## REVIEW OF RESPONSE TO COMMENTS ON WORK PLAN ADDENDUM ONE FOR MISSION TRAILS EQUESTRIAN CENTER, EAST ELLIOT, CAMP ELLIOTT, SAN DIEGO, CALIFORNIA

**Interim Quality Assurance Audit Evaluation**  
**On**  
**Global Mapping System's Digital Geophysical Survey**  
**For the**  
**OE Construction Support Project**  
**At the**  
**City of San Diego's Construction Site**  
**Mission Trails Equestrian Staging Area**  
**Located on the**  
**Formerly Used Defense Site (FUDS)**  
**Camp Elliot-East Elliot (J09CA006703)**  
**Mission Trails Regional Park, San Diego CA**

**July 28, 2003**

**Figure 3: Test strip profile plot (vertical scale is Channel 3 reading in mV)**

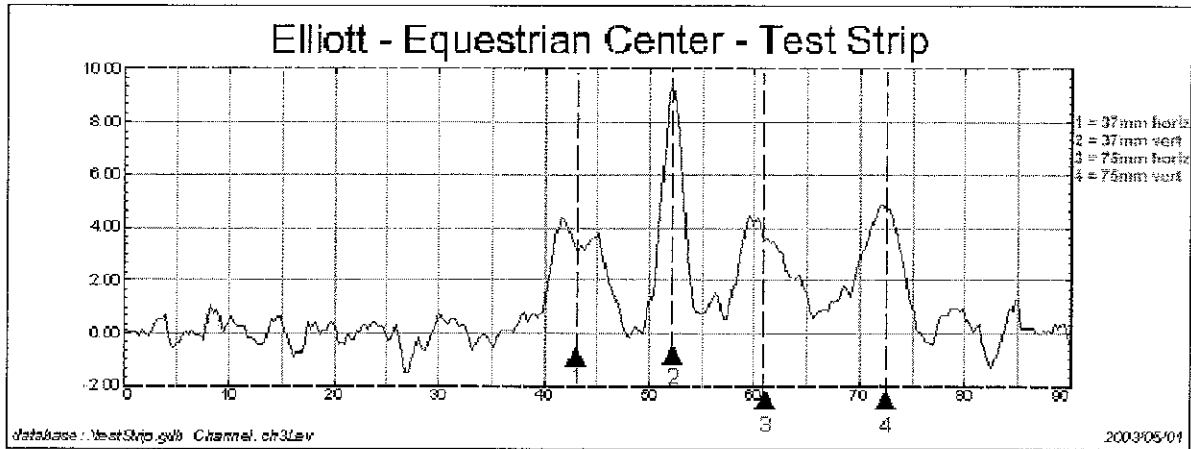
Upon Government review of the data, it was determined that the seed item locations originally submitted by the contractor were possibly inaccurate. An Interim QA Report was sent to the project PM by email on May 1, 2003 including this concern. The following is the comment addressed in the interim QAR, and the resolution received on May 18, 2003:

**QA Comment:** The seed item locations for the test strip appear to be inaccurate based on the responses seen on the attached profile plot. The higher amplitude, sharper peak response seen for seed item 2 is more consistent with a vertical orientation than horizontal. Likewise, the double peak response evident in seed item 1 is more consistent with a horizontal orientation.

**Response from GMS:** *The order and orientation of the seed items in the test strip were transmitted incorrectly. The correct position and orientation of the test strip items is shown in the attached Teststripfinal.shp and Teststrip1.pdf files.*

*The correct order of the seed items listed from Southwest to Northeast is as follows.*

1. 37mm Horizontal
2. 37mm Vertical
3. 75mm Horizontal
4. 75mm Vertical

**Figure 4: Geophysical Data Map** (from original exclusion area Shape Files)

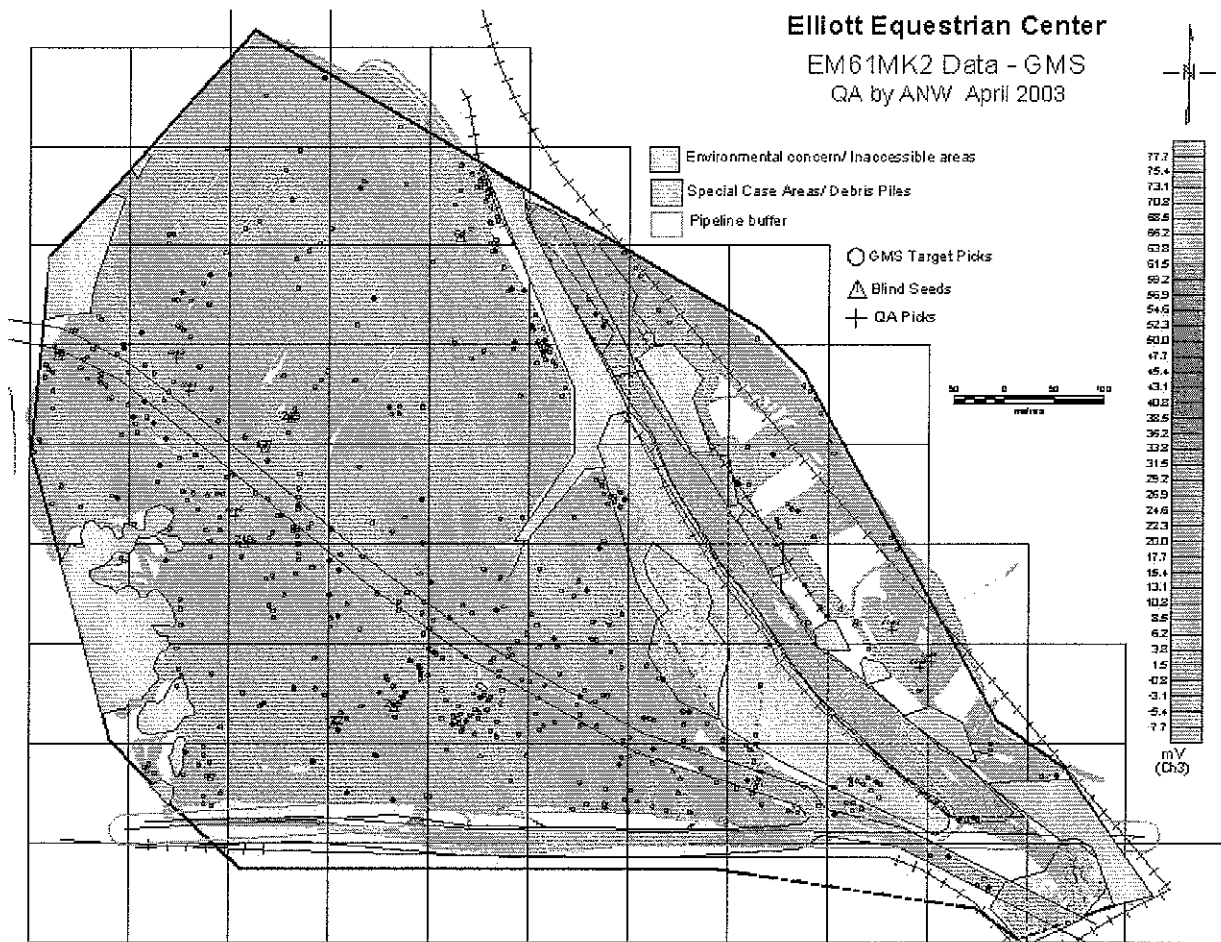
- (1) **QA comment:** There appears to be large areas of missing data. Attached is a data map, the blue areas are known environmental concern/inaccessible/special case areas and the white is data gap areas (large areas on the east side and south of the pipeline). The data gaps (white areas) could be caused by several factors: (1) the

areas are inaccessible or environmentally sensitive and removed from the geophysical coverage area, (2) the data was collected, but not transmitted on the data CD, or (3) the data was not collected and is still needed to meet project objectives. It is entirely possible that I don't have complete information on which areas were to be mapped and that the first alternative is the correct one.

***Response from GMS:*** *The area south of the pipeline was not geophysically mapped for the following reasons. The southern site perimeter is located within a posted environmentally sensitive area. The Northern boundary of the environmentally sensitive area is fenced using telephone poles and connected with steel strapping material. The short distance between the pipeline buffer and the southern fence restricted the area that could be surveyed from a geophysical and in many cases, a physical standpoint. The exclusion of these areas was discussed with the USACE Safety Specialist, USACE Biologist and Prime Contractor prior to designating the area as not mappable. The attached ArcView shapefiles (Enviro\_fnl\_v3.shp and Brush\_terrain\_fnl\_v2.shp) have been provided to exclude this area.*

*Data gaps identified in the Southwest corner of the project area are a result of using the incorrect environmental shapefile. The corrected shapefile (Enviro\_fnl\_v3.shp) has been provided to accurately display the environmentally sensitive areas in this region.*

*The areas that were not mapped between the Special Case Areas and the Northern boundary were excluded due to a combination of factors. These factors included concentrations of Pacific Coastal Sage, construction debris, and terrain that was both hazardous and would yield unreliable geophysical data.*

*Concentrations of Pacific Coastal Sage were identified throughout the project area by the USACE Biologist assigned to the project. After discussions with site personnel, it appears that the USACE Biologist flagged areas on the North Slope as environmentally sensitive while the geo team was mapping in this area. These areas were not reported to the GMS surveyor for mapping. The geo mapping crew avoided the area due to the flags. The flags were then removed by the Biologist, (possibly because he changed his mind) but the area was not collected. A miscommunication between GMS and the Biologists may have been the reason for a number of these data gaps. It is recommended that the USACE Biologist be available to resolve these areas when GMS provides cleanup of the data gaps.*

*To resolve existing data gaps, GMS plans to mobilize and collect the missing data at least 3 days prior to the reacquisition/anomaly investigation event, at no additional cost to the government. It is recommended that the USACE Biologist be available at this time to resolve areas located on the North slope.*

**Figure 5: Updated Geophysical Data Map** (with new shape files from GMS) – Data collected inside the Special Case and Pipeline Buffer Areas has been brought to the front of the map and is bounded by the light blue polygon. See section 2.5 for discussion of anomalies within this area.

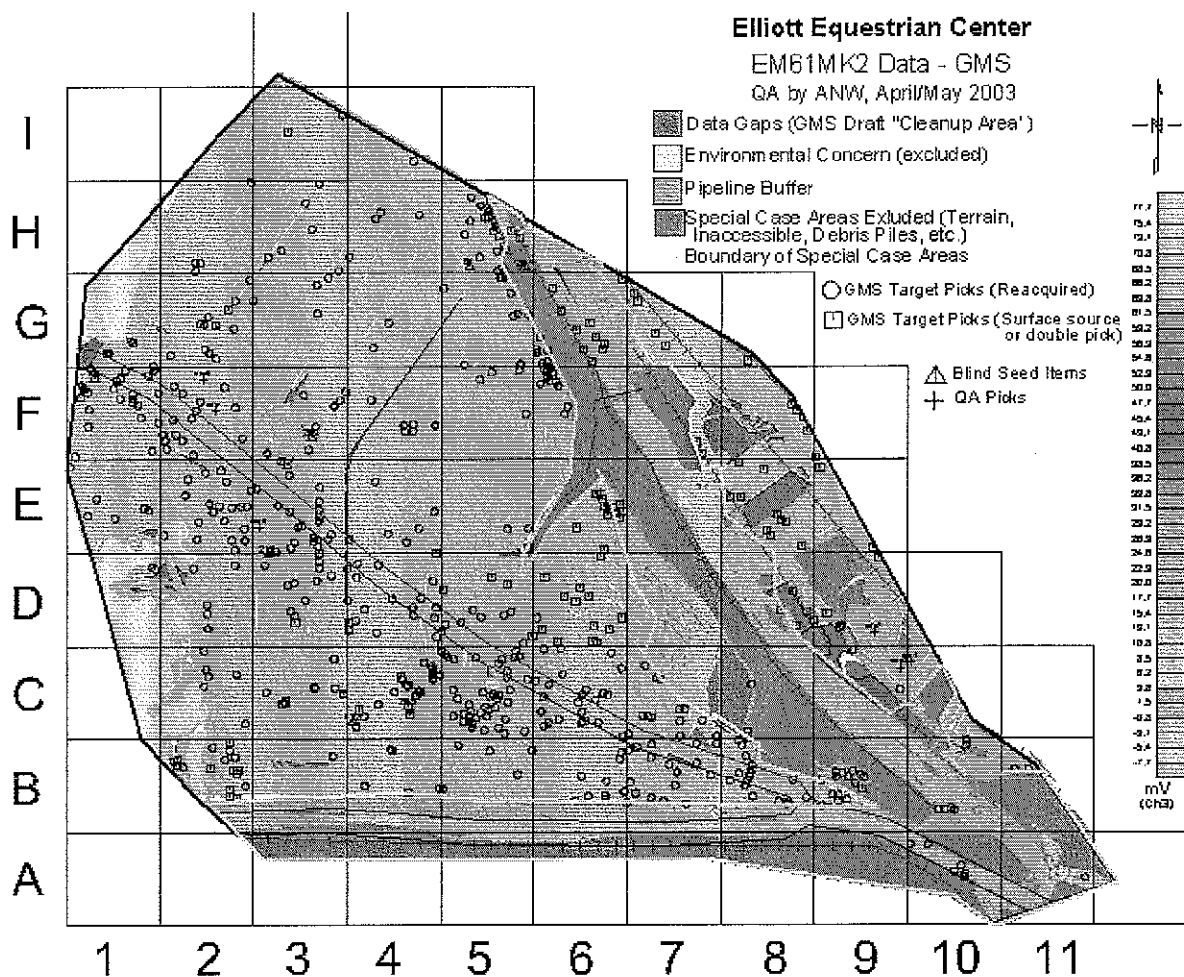
- (2) **QA comment:** There are also numerous data gaps caused when the lane spacing objective of 25 feet is not being met. This could become a significant issue if 37mm's are found during intrusive work. Because of their small size, they could easily be missed with the larger lane spacing. It may be less significant if no OE is found during the initial intrusive work.

The initial Cleanup Plan (red areas) does not address all of the data gaps due to increased lane spacing. It is the author's opinion that all of the red areas should be geophysically mapped and all target anomalies dug. In addition, all areas where the lane spacing exceeds 3 feet should be filled in. The original lane spacing of 2.5 feet was used to ensure that full coverage was obtained, giving some room for error in positioning and some coil overlap. Because of the physics and operation of the EM61 instrument, the detecting capabilities are focused inside the coil, with significantly decreased detection outside of the coil. This is especially important for small target items such as 37mms. Therefore, any lines whose across-lane spacing exceeds 3 feet (the width of the EM61 coil) should be filled in with additional geophysical data.

**Response from GMS:** GMS concurs with Ms. Walker. The data gaps that have been identified as a result of lane spacing are missed coverage. This may be a result of blanking distance, GPS antenna tilt and some missed cleanup. GMS will map and process the remaining data gaps prior to the reacquisition/anomaly investigation event as explained previously. An initial cleanup plan is displayed in the attached ArcView shape file (Cleanup\_fnl\_v2.shp) and will be refined prior to the data gap cleanup event.

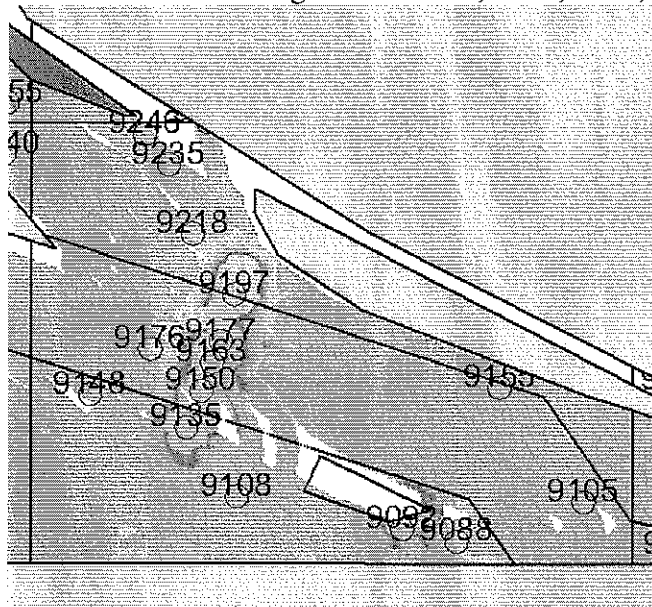
**QA Comment:** The target list shows ~19% of the targets as not reacquired, and some of these are large amplitude responses. I believe that they are probably due to surface/cultural features or picking multiple targets for one anomaly. However, there are no notes on the target spreadsheet to explain why they were not reacquired. Please have GMS send any additional documentation that they have to explain the high false positive rate.

**Response from GMS:** *The target spreadsheet provided as a part of the original submission (Draft Equestrian Target List.xls) has been amended (Draft Equestrian Target List v3.xls) to better explain the list. See notes at the end of the spreadsheet for explanation of fields.*

*During reacquisition, a number of the double targets and surface debris were resolved. In most cases, repeat targets were a result of the merging of multiple target databases and were rectified during the visual/reacquisition process. The total number of actual targets marked during the reacquisition was 455.*

**Figure 7: Suspected culvert causing anomalies**

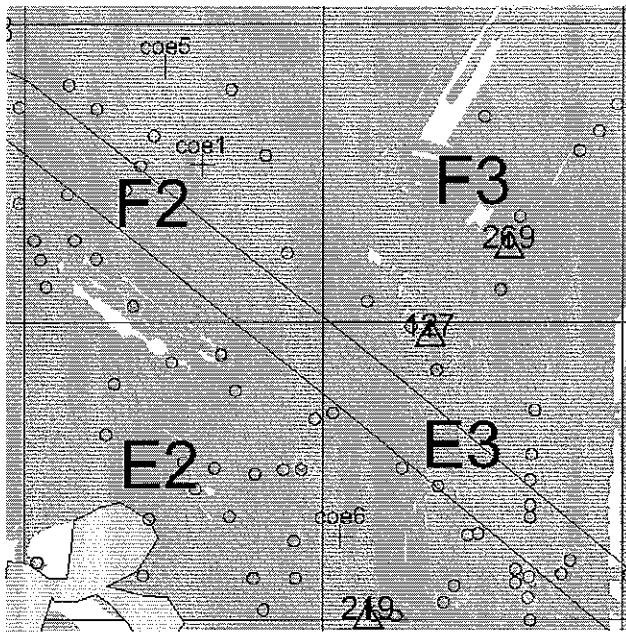
There are a few anomalies that were reacquired that should not be dug. First, anomaly number 95181 appears to be on the edge of an environmental concern area, and thus should be avoided. Additionally, some appear to be caused by a culvert beneath the road (in Grid B8). Recommend removing the following anomalies from the dig sheet: 95181, 9197, 9177, 9176, 9163, 9150, and 9195.

**Figure 8: QA Digs (shown by crosses)**

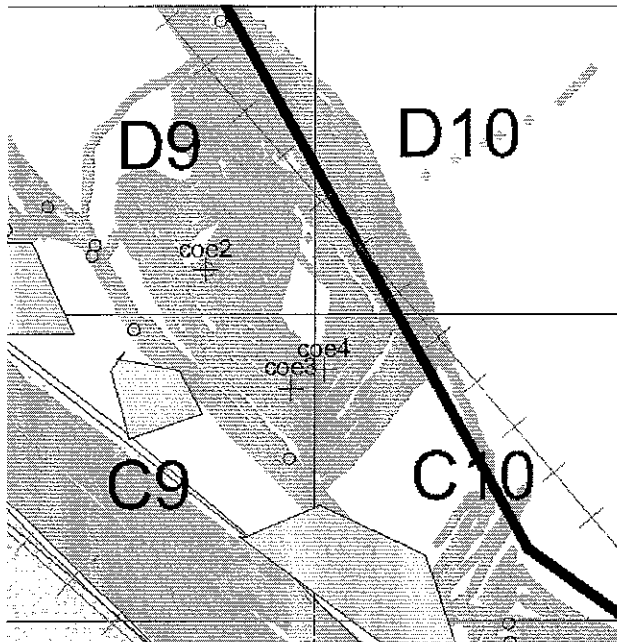
In addition to the targets selected and reacquired by the contractor, the government has made the following QA target picks. These targets should be reacquired and dug if no surface or cultural cause is detected.
